Proposed amended modification design (subject to approval) of the Crescent overpass and green link:

Application number SSI 7485

This is a submission drawing attention to significant shortcomings in the amended modification design for the proposed Crescent overpass. I object to these deficiencies and propose an alternative which overcomes the shortcomings.

.The actual Approved design is shown below. It provides direct links to both Rozelle and Annandale and to White's Creek and to the light rail station.

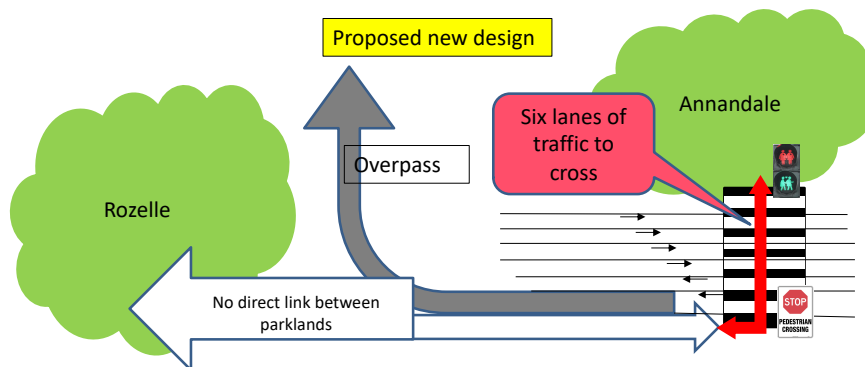
The original, approved, design for this section of the Westconnex project promised a direct, wide, green, shared link between Rozelle and Annandale. (see schematic below). Effectively, it promised to re-join the communities that have been divided by the goods yards and City West Link and provide a safe way for families, students etc to cross this divide.

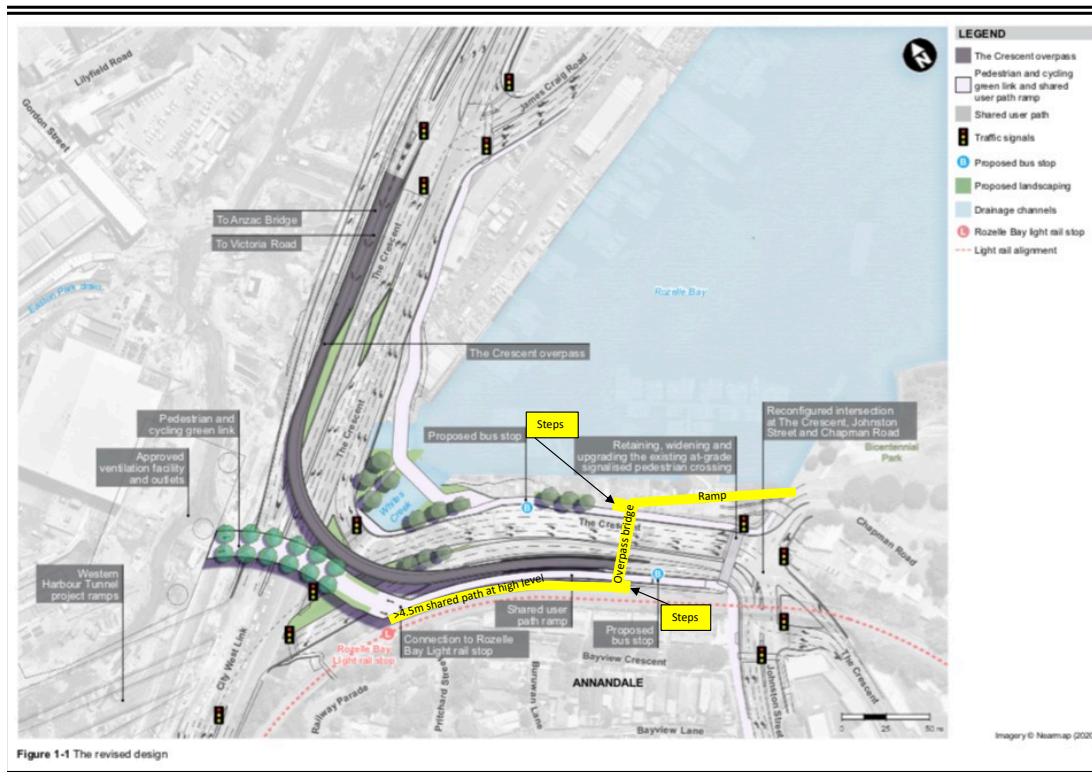
With the introduction of the new proposed overpass from the Crescent to City West Link, the direct, wide, green, shared link was lost and the modified proposal does not restore it. (See schematic diagram below).

What has been proposed is shared but is not direct; it is not especially wide and is only partially green. But the glaring issue is that the free movement of pedestrians and bike riders is brought to a dangerous, abrupt, halt by a pedestrian crossing and traffic lights. This arrangement is probably slightly better than the original proposal (with the traffic overpass) but it is still unsatisfactory and smacks of a lack of imagination and good-will. I think WestConnex can do much better.

At least the horseshoe bridge DID provide a direct link (without having road crossings) between Rozelle and Annandale parklands (even if it was a bit of an eyesore and was very long). But your modification has deleted this overpass/bridge.

Current (revised) proposal: Pedestrian crossing for 6 lanes of traffic to access foreshore

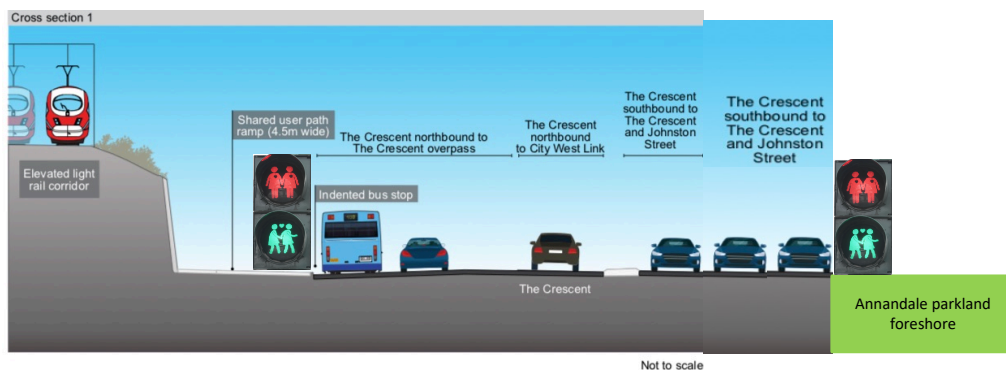
A cross section drawing at the point of the proposed overpass is shown below from the current design amendment. Below that is a superimposed impression of the proposed overpass and ramp.

Alternative with shared access direct to Annandale foreshore

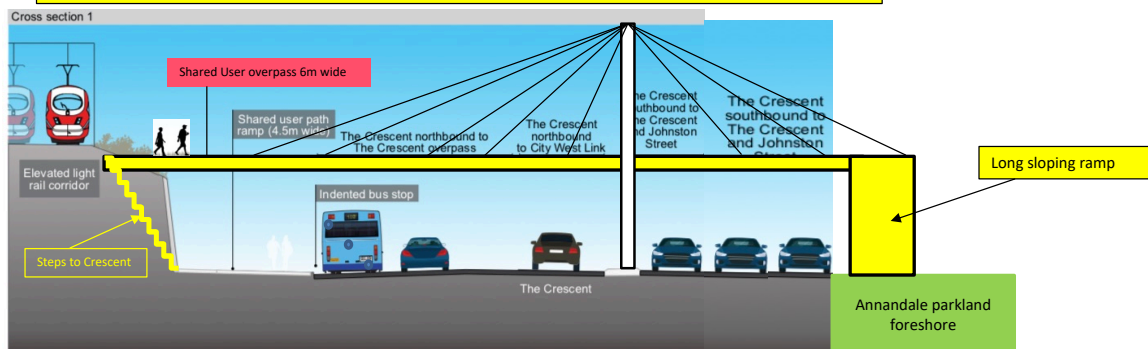
Basically, what I think could overcome this pedestrian-crossing-obstacle is a simple overpass of the crescent with a ramp to the foreshores on the Annandale side. (See diagram below).

There are many ways an overpass could be engineered for this situation and I have simply suggested a suspension type of bridge that can be constructed offsite and swung into position when ready. It has a single support in the median strip. The length of the access ramp would need to be adjusted to allow both pedestrians, bike riders and wheel chairs to access relatively easily. (The ramp could go either towards Bicentennial Park or towards Whites Creek (or both ...with dual ramps)).

The overpass and ramps could be made quite wide to accommodate appropriate “green” landscaping or sculptural treatment. The path alongside the light rail track could overhang (possibly cantilevered) the lower ramp for a considerable part of the distance and thus allow a wider path. And there is no real restriction on the width of the overpass itself apart from engineering/cost issues. I have suggested that it should be at least 6m (hopefully more) in keeping with the original approved design concept.
